Response to Representations, Agency and Council Comments – DA 26010577

This letter provides a response to the public representations received during notification of variation application DA 26010577. The public notification period concluded on 14 May 2026.

Figure 1 – Height comparison overlay showing stamped plans (red) and proposed variation (blue)

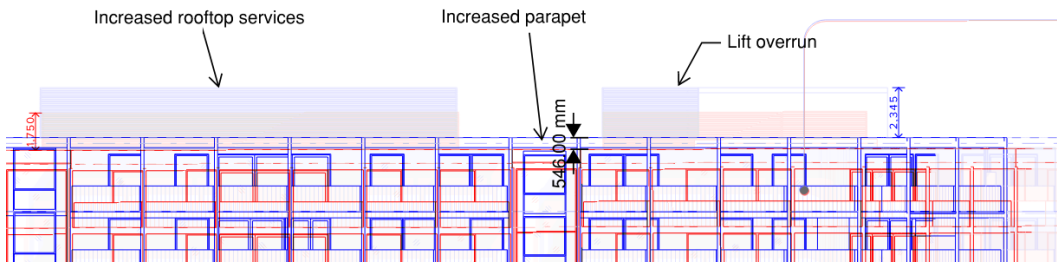
The representators raised concerns with the proposed height increase to the 10-level building.

- Building parapet – 546mm (1.7%) increase
- Rooftop services – 808mm (2.4%) increase

We have also prepared a height comparison overlay for the western elevation, see **Annexure C**. This shows a comparison between the stamped plans for DA 24029287 (shown in red) and the proposed variation (shown in blue).

Figure 1 shows the comparative height of the existing authorisation and what is proposed by this variation. This increased height is minor in the context of the 10-level building. Due to its location, the rooftop services will not be easily observed outside the site.

Much like the minimal change to shadowing, the minor increase in height will be inconsequential when viewed external of the site and in the context of the building itself.

UPDATED SHADOW CAST (WINTER)
 OUTLINE OF ORIGINAL SHADOW CAST
 REV02

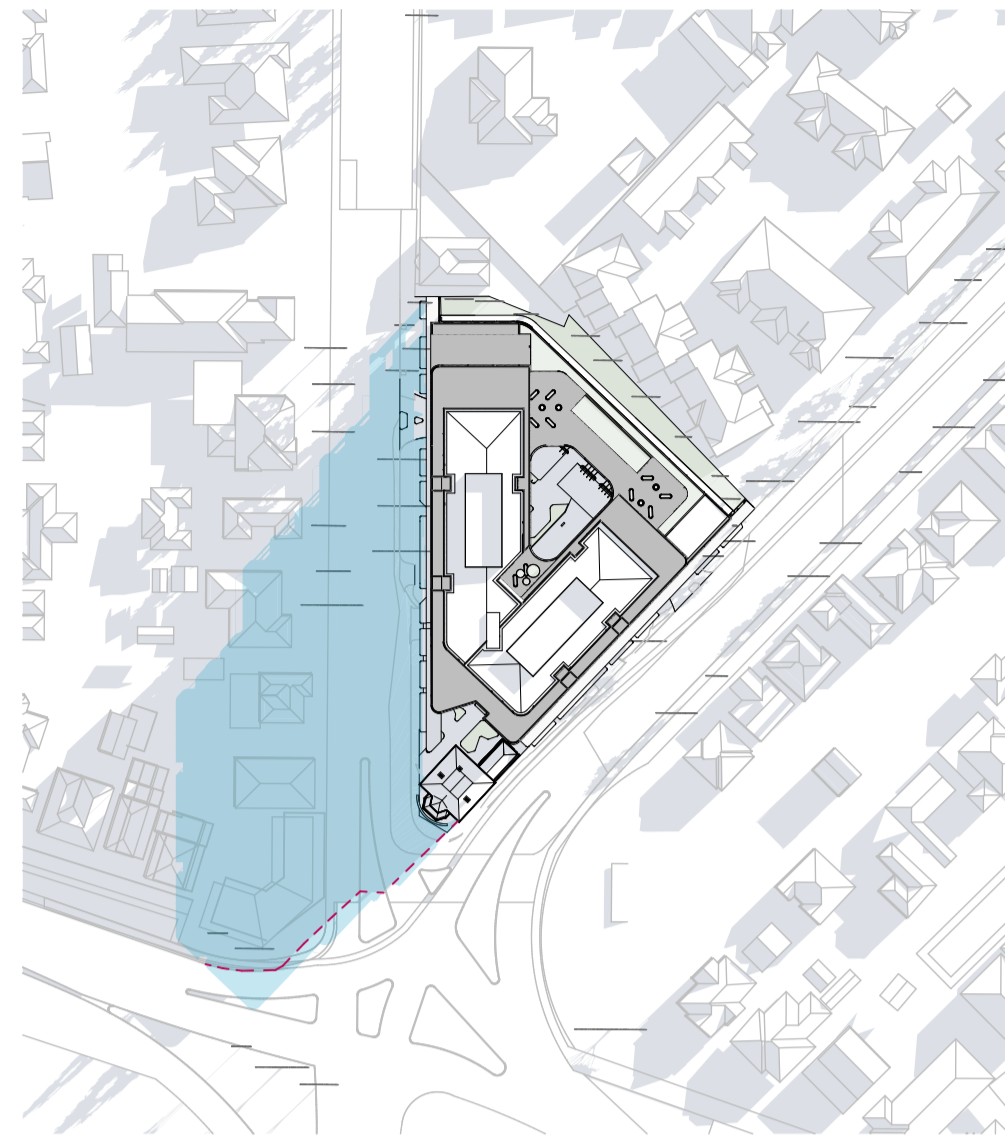
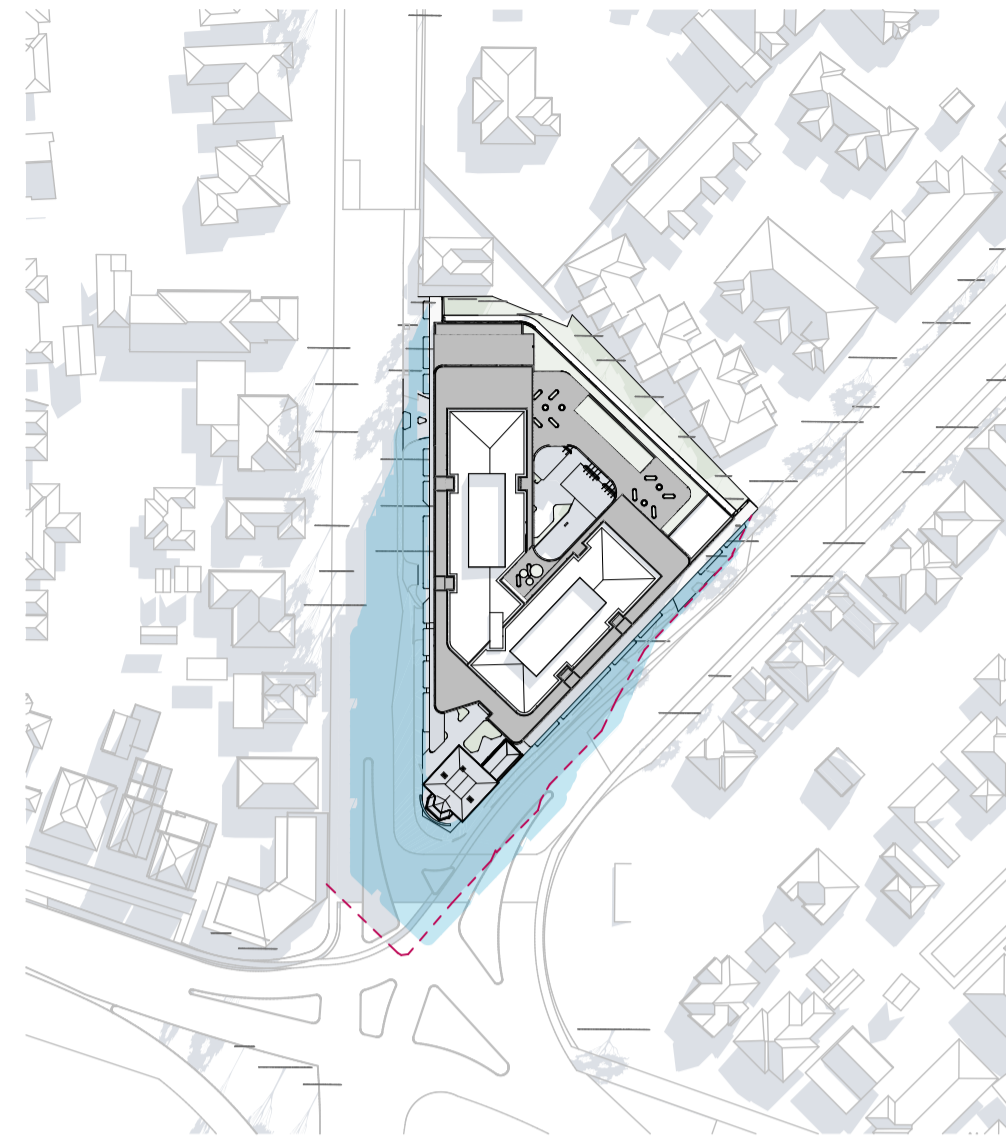
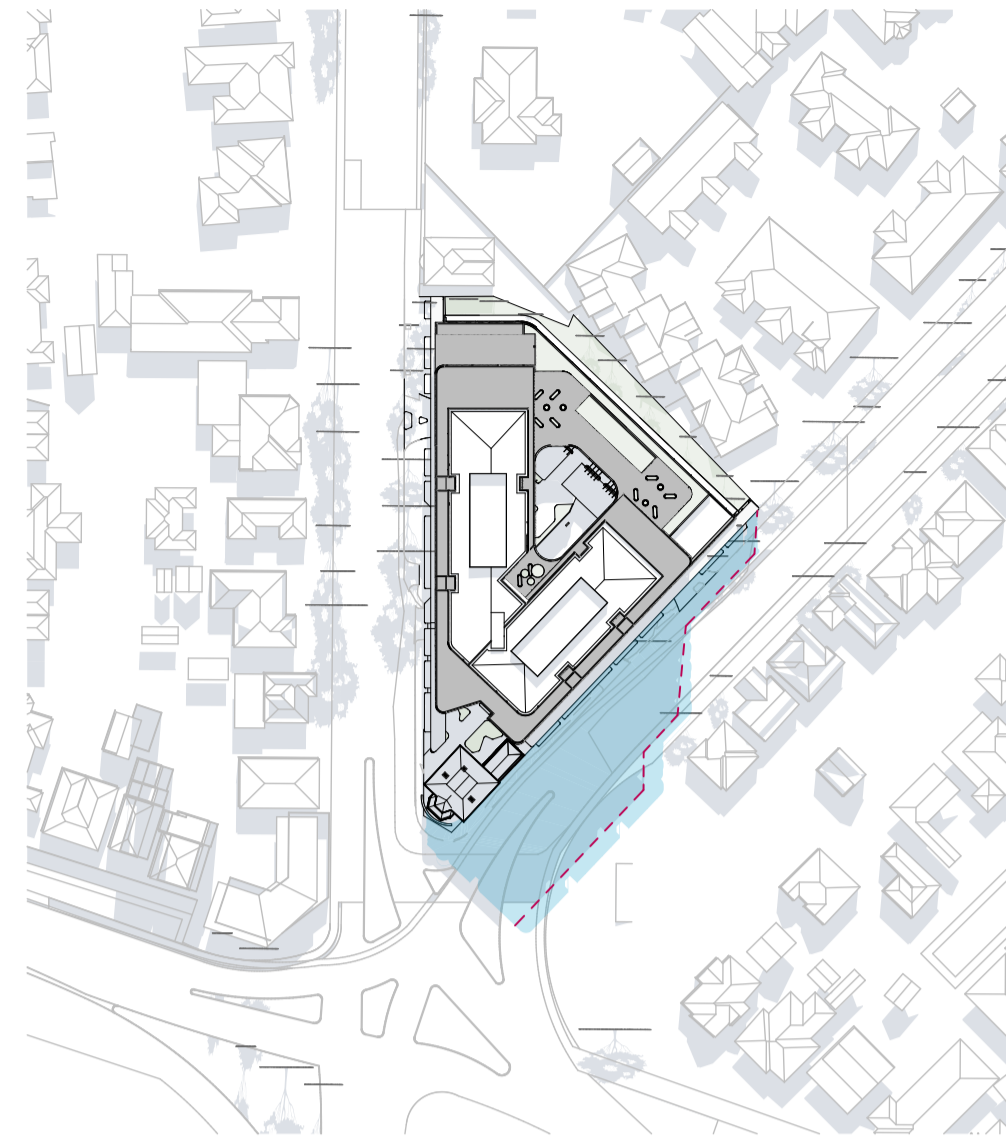
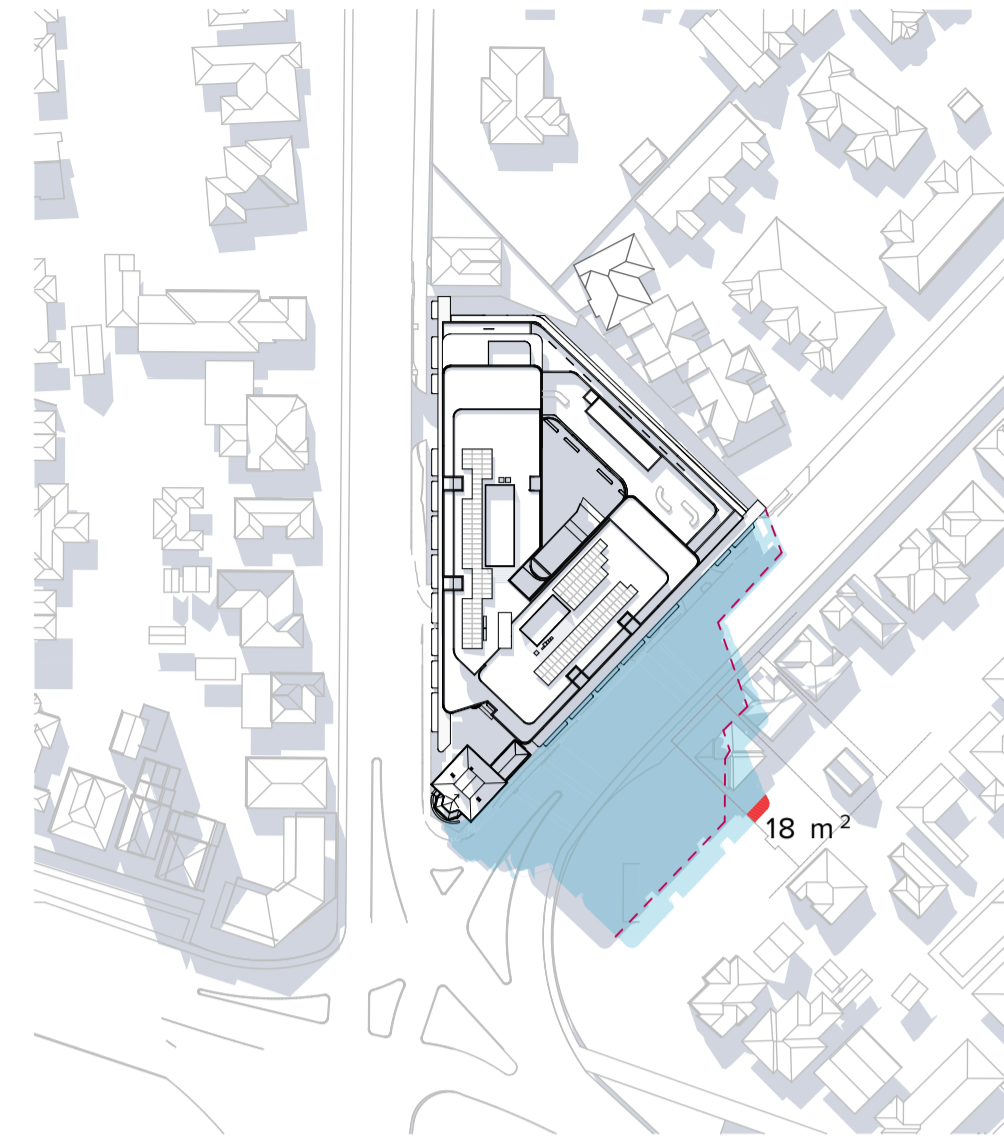
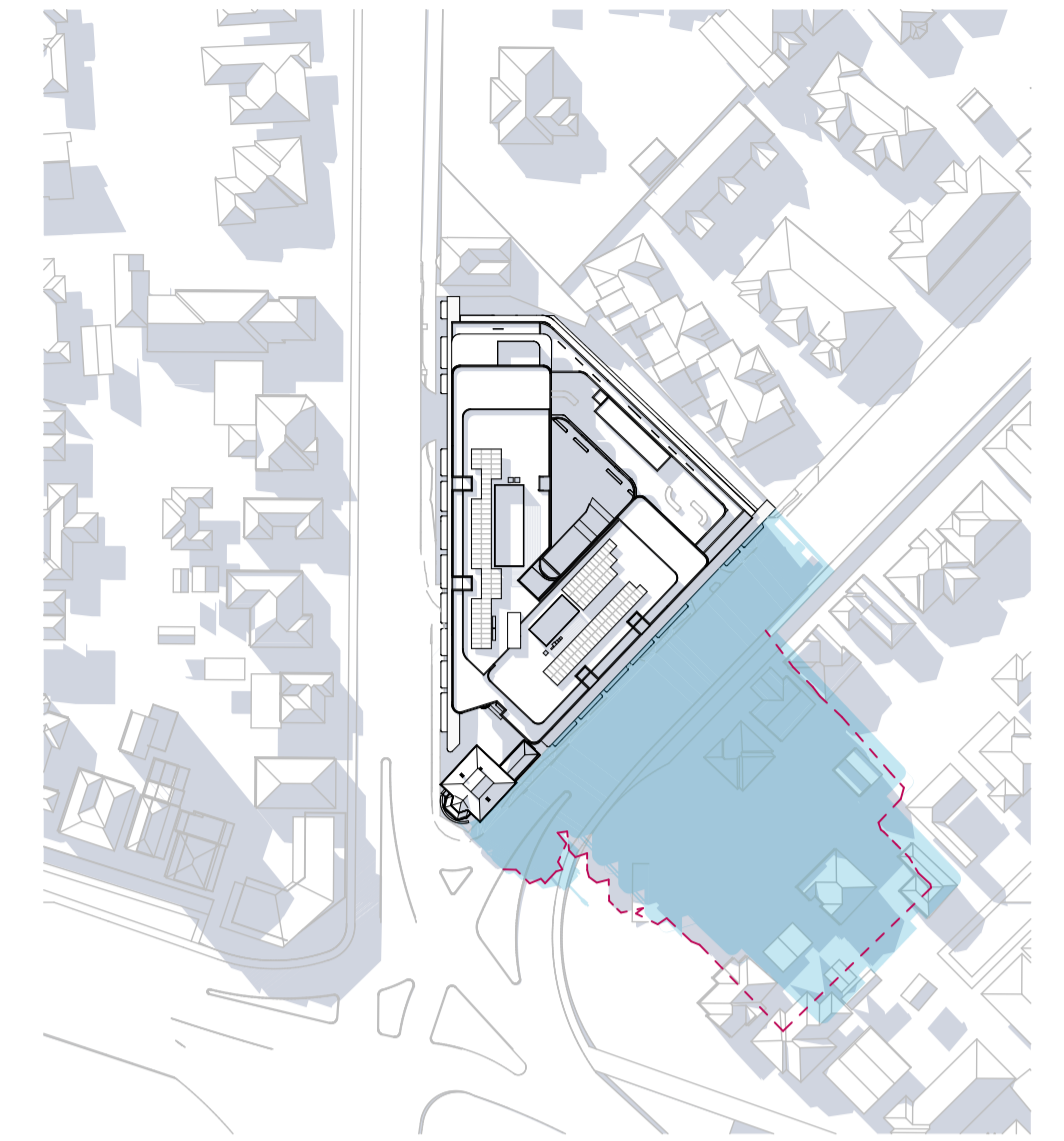
Representors raised concerns with the management of off-site and amenity impacts. This is primarily contained to overshadowing and overlooking.

Shadow analysis prepared by SMFA (see **Annexure A**) shows the additional shadows cast by the variation. This demonstrates that additional shadows are contained to public roads or the adjacent public reserve between the hours of 9am and 1.30pm on 21 June.

At 1.30pm an additional 18m² of shadowing is experienced within the private open space of 6 Walkerville Terrace. Despite this, the private open space receives at least 5 hours of unencumbered sunlight to satisfy DPF 3.2 above.

By 3pm there is no additional shadowing to private open space within 60m of the development (definition of adjacent land).
